STATE OF CONNECTICUT  
CONNECTICUT SITING COUNCIL

IN RE: :  
 :  
APPLICATION OF NTE CONNECTICUT, : DOCKET NO. 470  
LLC FOR A CERTIFICATE OF :  
ENVIRONMENTAL COMPATIBILITY AND :  
PUBLIC NEED FOR THE CONSTRUCTION, :  
MAINTENANCE AND OPERATION OF AN :  
ELECTRIC POWER GENERATING :  
FACILITY OFF LAKE ROAD, KILLINGLY, :  
CONNECTICUT : OCTOBER 27, 2016

APPEAL OF AND RESPONSES TO THE  
MUNICIPAL REGULATE AND RESTRICT ORDERS

**Revised Figure 7-5  
Results of Acoustical  
Modeling**

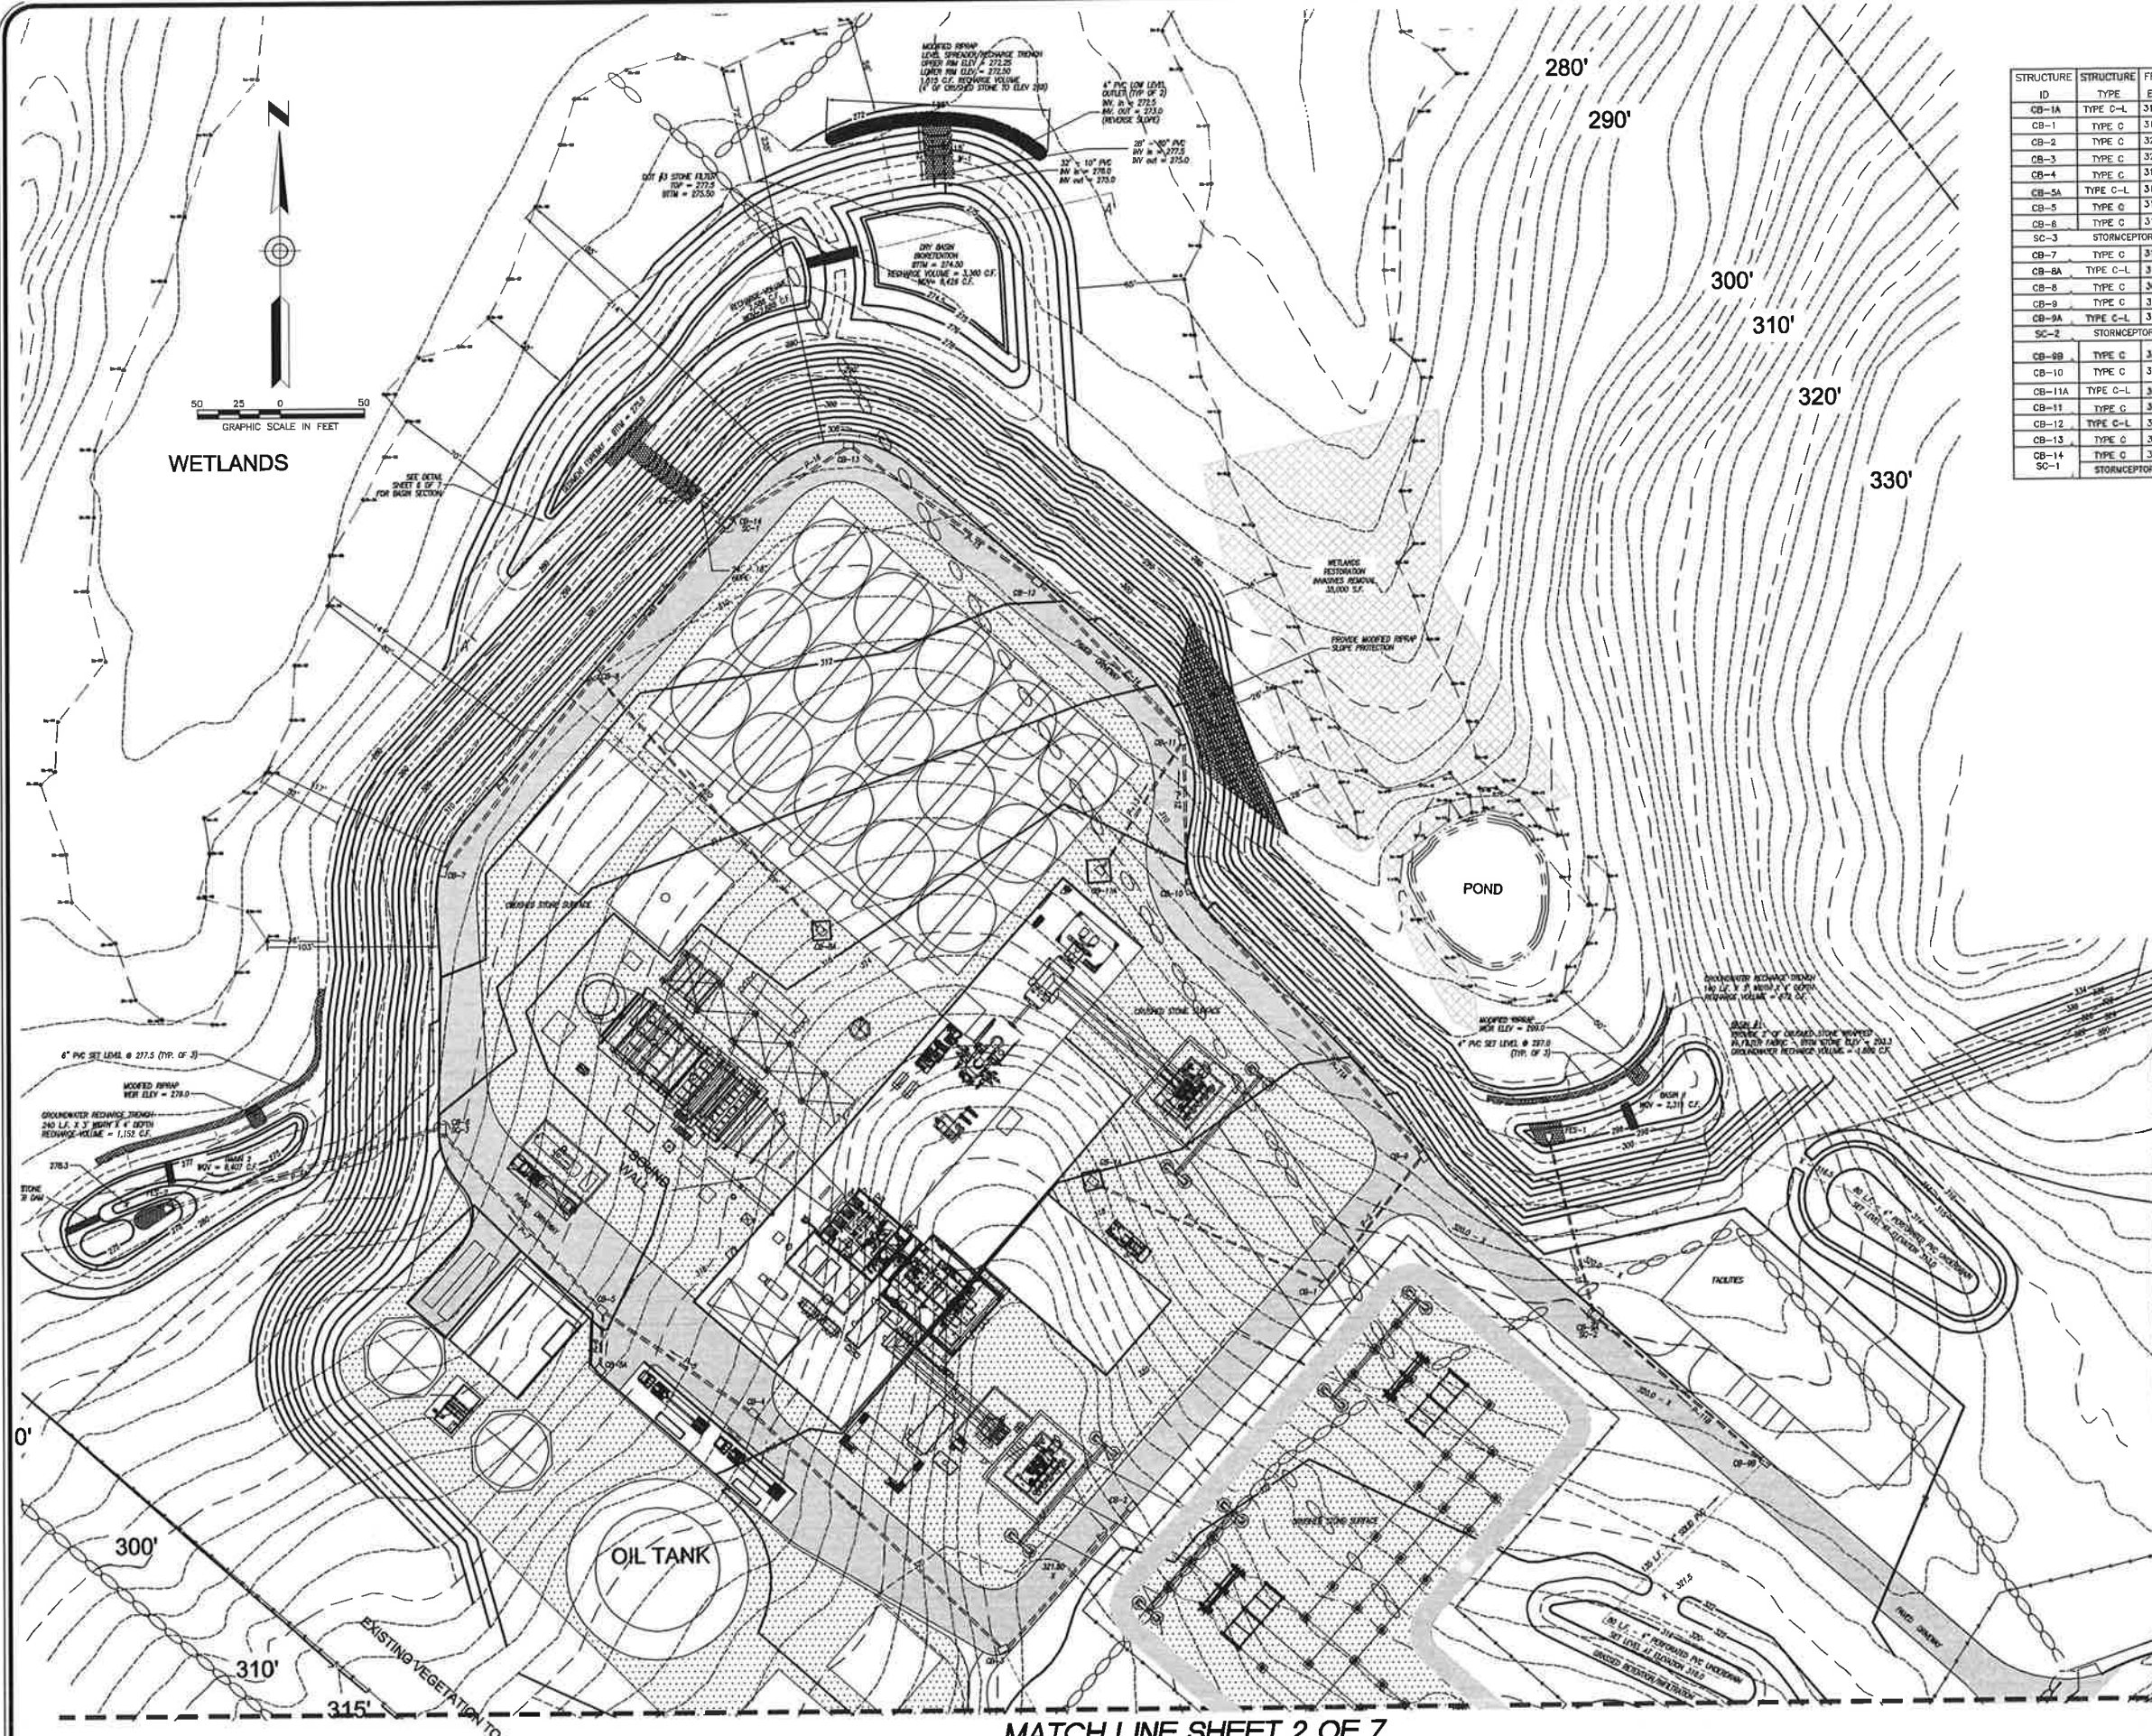
4) A statement is made that there would not be perceptible change in sound at locations near Alexander Lake, yet, there is no analysis of this within the report. Further, no ambient measurements were conducted near Alexander Lake to support this assertion. NTE indicates the noise contours show Project levels of 27 dBA or lower, and that the lowest nighttime measured anywhere was 26 dBA. However, the contours provided by NTE clearly show Project levels of greater than 30 dBA at Alexander Lake. Increased levels of 3 dBA or more are considered perceptible and applicant's data therefore indicates a perceptible change.

**NTE respectfully APPEALS this order. Modeled sound levels near Alexander Lake show decibel values ranging from the mid-20s to the low-30s dBA in the Application (Figure 7-5) and even lower levels for more of the Alexander Lake area in the Updated Noise Modeling, which reflects the layout refinements and the effect of intervening structures. KEC has demonstrated compliance with the stringent 51 dBA limit applicable at the property boundaries and sound levels at Alexander Lake are well below that limit. Imperceptibility or inaudibility under all operating conditions is not required by the Town of Killingly or the State of Connecticut, and is an unrealistic expectation for this Project or any other industrial or commercial activity.**
